Access Compliance Report

Public Rights-of-Way

(Curb Ramps)

Intersection ID: 8379	Main Street: NEWLAND_RD	Cross Street: CATHERINE_SIMMONS_AV	Location: NW
ADA ID: AF09BF5F5694	Ramp Type: Perp	Initial Pass/Fail: Fail	Overall Compliance: No
Severity Score: 33.75			
Codes/Mitigation Info/Possible Solution		Field Measurements/Component Compliance

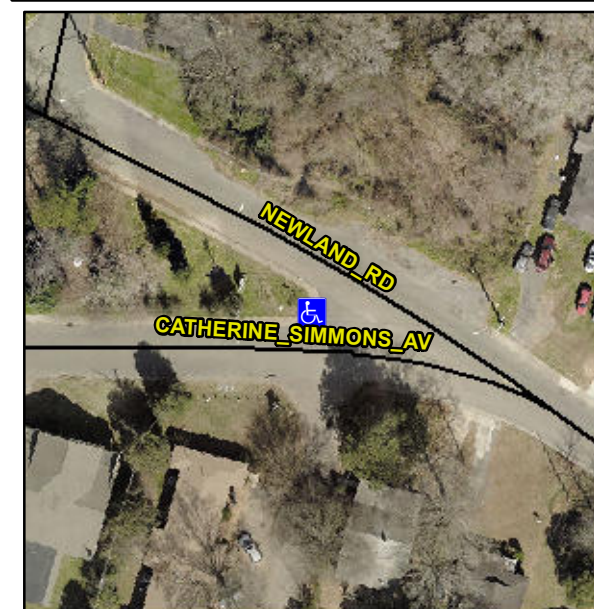
Not Found, R304.5.1, R304.5.3

Compliance	Description	Data	Compliance	Description	Data
N/A	Ramp Length (in)	46.0	Yes	Ramp Slope (%)	6.5
No	Ramp Width (in)	46.0	No	Ramp XSlope (%)	9.5
N/A	Flare Type LT	N/A	N/A	Flare Type RT	N/A
N/A	Flare Slope LT (%)	N/A	N/A	Flare Slope RT (%)	N/A
N/A	Flare Traversable LT?	N/A	N/A	Flare Traversable RT?	N/A
N/A	Landing Length (in)	N/A	N/A	DWS Provided?	N/A
N/A	Landing Width (in)	N/A	N/A	DWS Contrast?	N/A
N/A	Landing Slope (%)	N/A	N/A	DWS Length (in)	N/A
N/A	Landing X Slope (%)	N/A	N/A	DWS Full Width?	N/A
N/A	Landing Curb? (Y/N)	N/A	N/A	DWS Offset (in)	N/A
N/A	Shared Landing?	N/A			
N/A	Gutter Ponding?	N/A	N/A	Gutter Slope (%)	N/A
N/A	Gutter Lip Ht (in)	N/A	N/A	Gutter X Slope (%)	N/A
N/A	Painted X Walk1?	No	N/A	Painted X Walk2?	N/A
	X Walk 1 Direction	To SE		X Walk 2 Direction	N/A
N/A	X Walk 1 Width (in)	N/A	N/A	X Walk 2 Width (in)	N/A
	X Walk 1 Slope (%)	2.0		X Walk 2 Slope (%)	N/A
	X Walk 1 X Slope (%)	7.8		X Walk 2 X Slope (%)	N/A

Remove & Replace Entire Ramp.
